October 12, 1985
ST-HL-AE-1403
File No.: G9.17

South Texas Project
Units 1 and 2
Docket Nos. STN 50-498, STN 50-499
Response to NRC Draft Safety
Evaluation Report Open Item 11.4-2
and FSAR Open Item 11.4-31

Attachment: Revised FSAR Figures 11.4-1 & 2

Figure 11.4-1

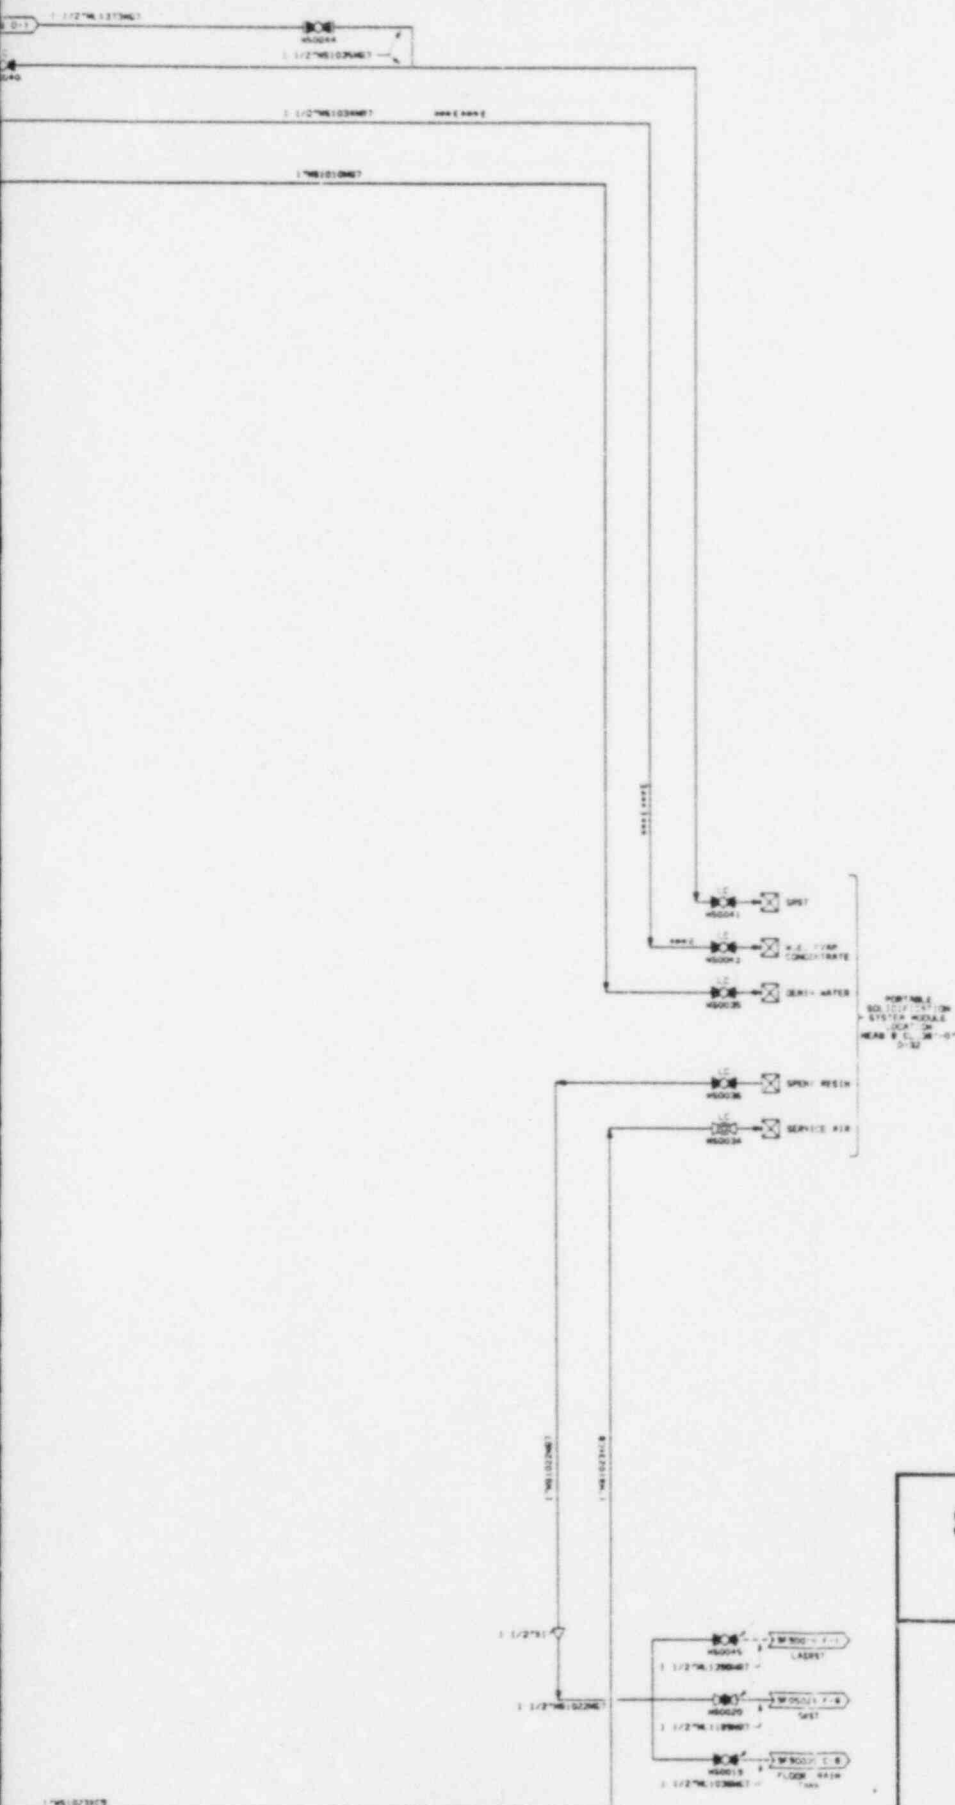
The NRC Draft Safety Evaluation Report (DSER), Section 11.4, Open Item (O/I) 11.4-2, requested that Houston Lighting & Power Company (HL&P) provide a process and instrumentation diagram for the solid waste processing system. In response to that request, attached are revised FSAR figures 11.4-1 and 2. This is also the same as FSAR O/I 11.4-31. These figures will be incorporated into the FSAR as part of Amendment 52.
